MEMO

To: Planning Commission
From: Hector Soto, Jr., AICP, Senior Planner
CC: File
Date: December 30, 2024
Re: Appl. #PL2024-025 - REZONING from RP-3 and CP-2 to RP-4 and PMIX, PRELIMINARY DEVELOPMENT PLAN and CONCEPTUAL DEVELOPMENT PLAN - Ovation, 325 SE M-150 Highway; Engineering Solutions, LLC, applicant

Figure 1 - Original townhome design with 1-car garages.

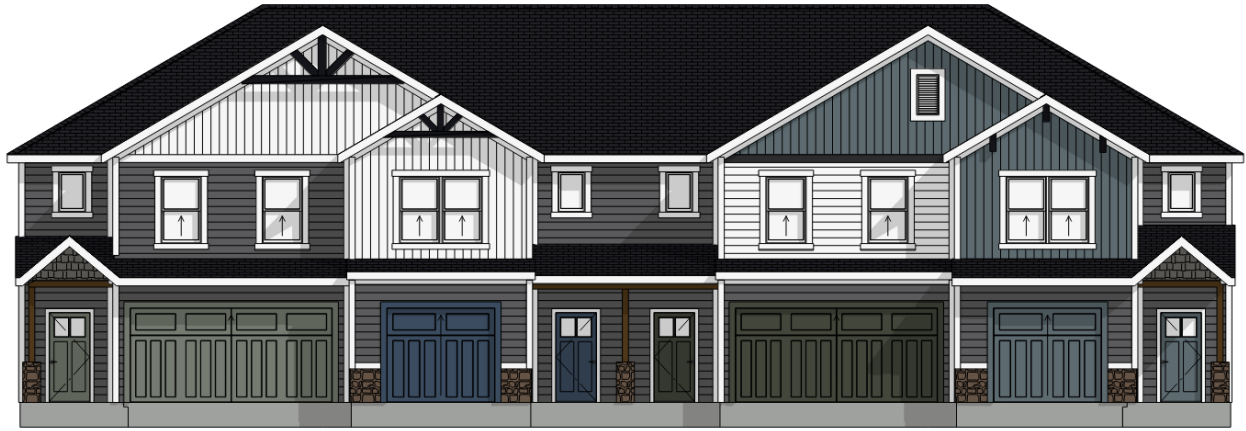
The image below illustrates the change in the proposed townhome design from 1-car garage units to a mix of 2-car and 1-car garage units. With the design change, the number of off-street parking spaces per building increases from 8 (4 garage spaces + 4 driveway spaces) to 12 (6 garage spaces + 6 driveway spaces).
